# RB147-09/10

Table R703.4, R703.11.2, R703.11.2.1, R703.11.2.2, R703.11.2.3, Table R703.11 (New)

## Proposed Change as Submitted

**FIGURE R802.5.1**  
**BRACED RAFTER CONNECTION**

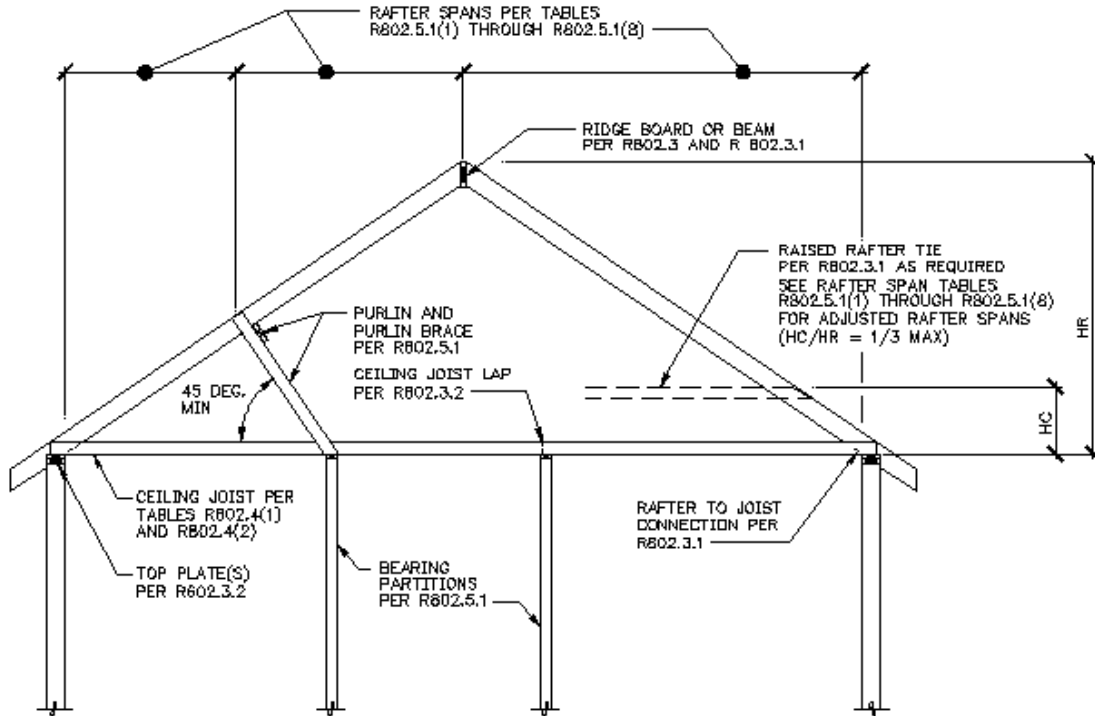
**Delete existing Figure R802.5.1 and replace as follows:**

**Reason:** The existing figure is lacking in some information and references to pertinent sections of code. This proposal updates the figure.

**FIGURE R802.5.1  
BRACED RAFTER CONNECTION**

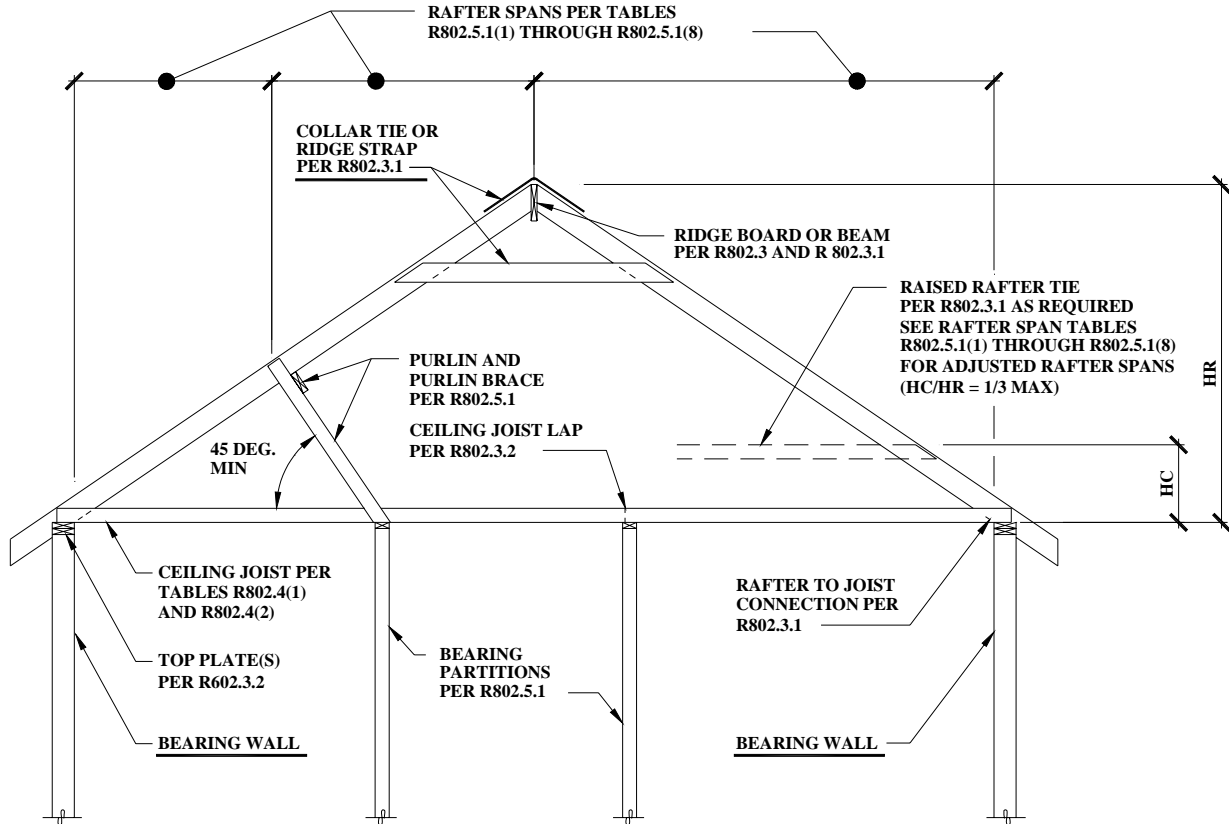
Modify the proposal as:

**Committer's Reason:** The figure submitted in the original proposal was approved As Submitted by the committee in Baltimore. This modification merely adds the collar tie/ridge strap requirement and a note to see R802.3.1. The requirements already exist in the code. This amendment does not add any requirements to the code. Also, notes were added stating that the exterior walls are bearing walls.

**FIGURE R802.7.1.1**  
**RAFTER NOTCH**

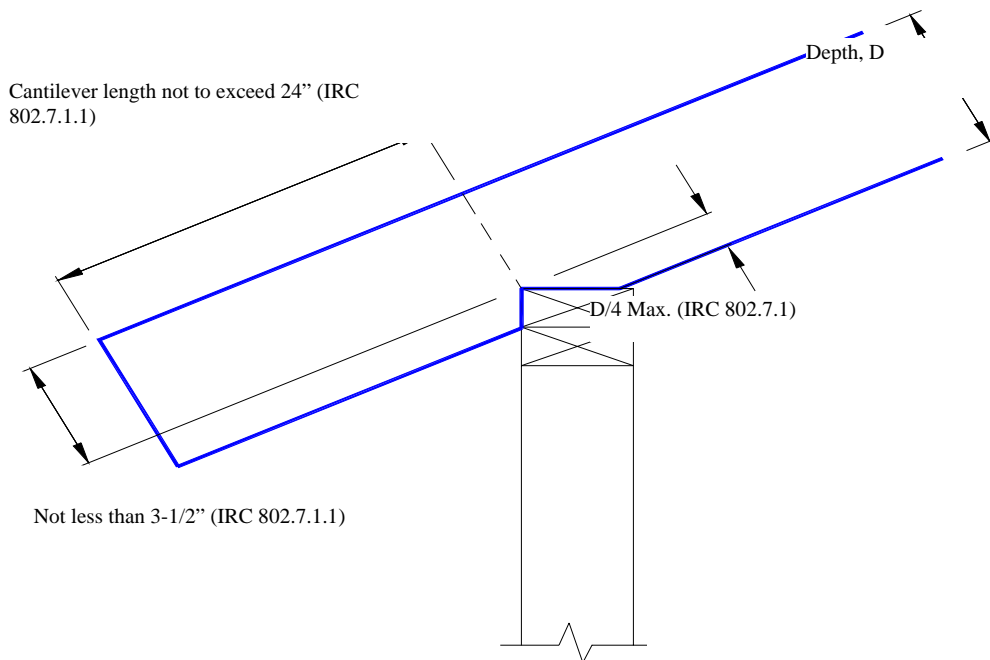
**R802.7.1.1 Cantilevered portions of rafters.** **Exception:** Notches on cantilevered portions of rafters are permitted provided the dimension of the remaining portion of the rafter is not less than ~~4~~ 3-1/2-inch nominal (102.89 mm) and the length of the cantilever does not exceed 24 inches (610 mm) in accordance with Figure R802.7.1.1.

### 2. Add new figure as follows:

**FIGURE R802.7.1.2**  
**CEILING JOIST TAPER CUT**

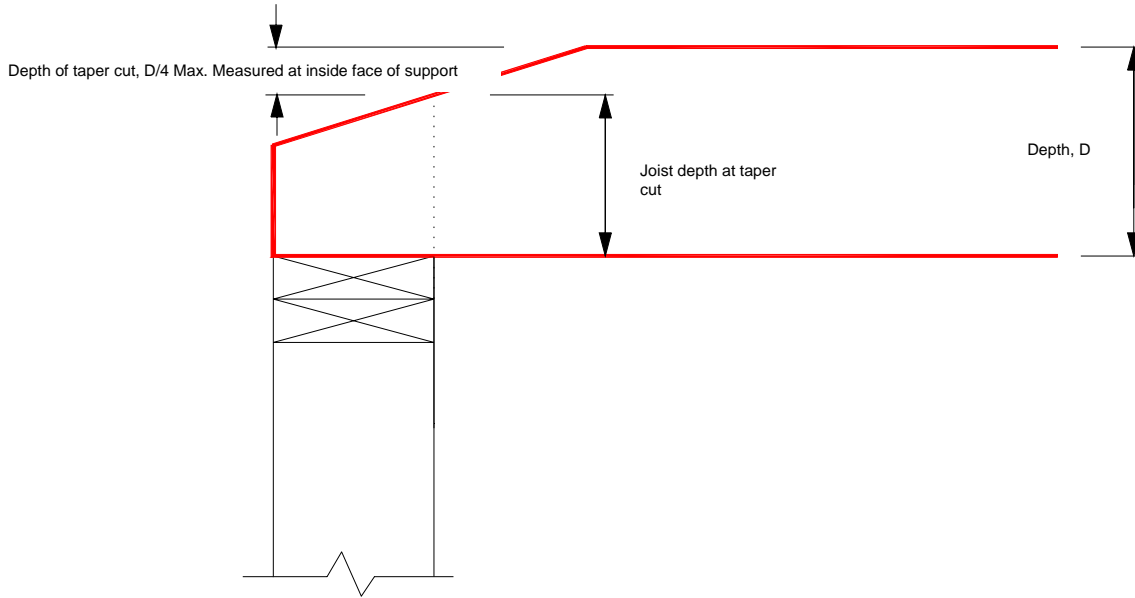
**R802.7.1.2 Ceiling joist taper cut.** Taper cuts at the ends of the ceiling joist shall not exceed one-fourth the depth of the member in accordance with Figure R802.7.1.2.

**4. Add new figure as follows:**
